Your Vehicle: 2000 SVT F-150 Lightning
Your Vehicle Identification Number: 12345678901234567
Program: 01B81

Retain Your Power With A New Supercharger Intercooler.

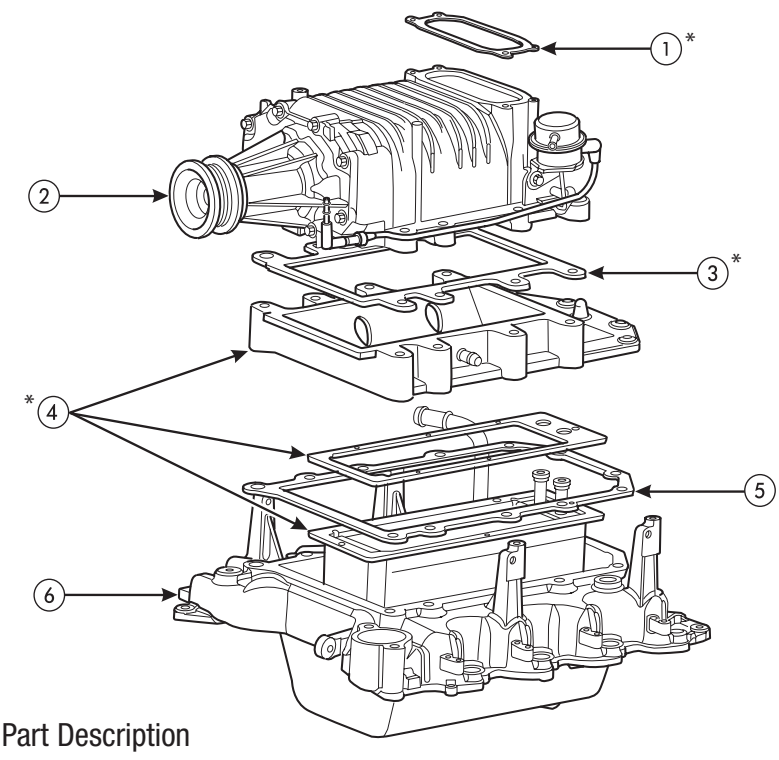
A. Dealers will replace a component of the supercharger's intercooler system. This component is known as the charge air cooler (CAC), commonly referred to as the intercooler. The intercooler will come pre-assembled with a new upper intake manifold and gasket as shown in the illustration above (item 4). All other necessary gaskets will be replaced.

A. In some of the affected vehicles, the intercooler may fracture and create an internal coolant leak. If this occurs, the vehicle may experience loss of engine performance at full throttle. Because the intercooler is a new design (the same as the 2001 design), a new upper intake will be installed to adapt it to the current supercharger.

A. The root cause of this condition is excessive stress on the aluminum extruded intercooler tubes due to heat cycling and thermal expansion contraction. This causes the intercooler tubes to fatigue and develop a hairline fracture.

A. The service part has been redesigned to reduce stress in the critical area. It is the same part that was introduced on the 2001 SVT F-150 Lightning.
